Access Compliance Report

Public Rights-of-Way

(Curb Ramps)

Intersection ID: N/A	Main Street: BOYCE_RD	Cross Street: TOBIN_CT	Location: NE
ADA ID: 669B8EB88CE5	Ramp Type: Directional1	Initial Pass/Fail: Fail	Overall Compliance: No
Codes/Mitigation Info/Possible Solution		Field Measurements/Component Compliance	
Severity Score: 13.75

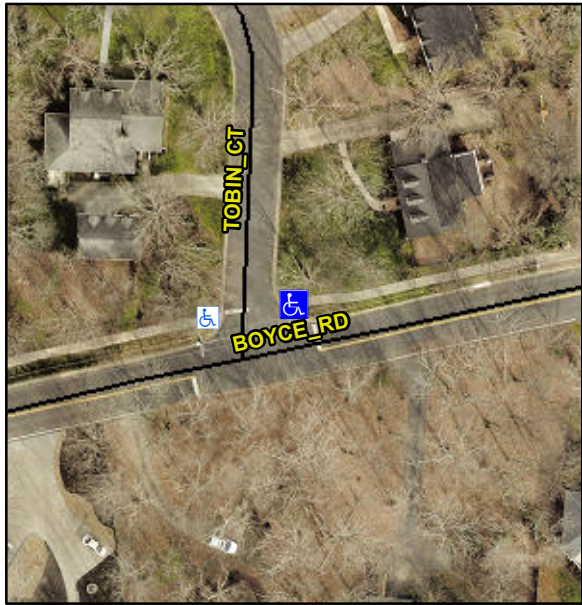
Compliance	Description	Data	Compliance	Description	Data
N/A	Ramp Length (in)	88.0	N/A	Grade Break?	N/A
Yes	Ramp Width (in)	48.0	N/A	Grade Break Slope (%)	0.0
No	Ramp Slope (%)	8.4	N/A	Grade Break XSlope (%)	0.0
No	Ramp XSlope (%)	3.7			
N/A	Flare Type LT	N/A	N/A	Flare Type RT	N/A
N/A	Flare Slope LT (%)	N/A	N/A	Flare Slope RT (%)	0.0
N/A	Flare Traversable LT?	N/A	N/A	Flare Traversable RT?	N/A
N/A	Landing Length (in)	0.0	N/A	DWS Provided?	N/A
N/A	Landing Width (in)	0.0	N/A	DWS Contrast?	N/A
N/A	Landing Slope (%)	0.0	N/A	DWS Length (in)	N/A
N/A	Landing X Slope (%)	0.0	N/A	DWS Full Width?	N/A
N/A	Landing Curb? (Y/N)	N/A	N/A	DWS Offset LT (in)	N/A
N/A	Shared Landing?	N/A	N/A	DWS Offset RT (in)	N/A
N/A	Gutter Ponding?	0.0	N/A	Gutter Slope (%)	N/A
N/A	Gutter Lip Ht (in)	0.0	N/A	Gutter X Slope (%)	N/A
N/A	Painted X Walk1?	No		Road Slope (%)	0.0
	X Walk 1 Direction	To W		Road X Slope (%)	6.4
	X Walk 1 Width (in)	N/A		Clear Space?	N/A

X Walk 1 Slope (%)	0.0	N/A	Clear Space to XWalk (in)	N/A
	X Walk 1 X Slope (%)	6.4	N/A	Storm Grate/Utility Hazard?	N/A
N/A	Ramp inside XWalk1?	N/A		Storm Grate/Utility Type	
N/A	Any Obstructions?	N/A			N/A
	Obstruction Type		Yes	Surface Condition? (G/P)	Good
		N/A	N/A	Curb Slope (%)	4.9

Remove & Replace Entire Ramp.
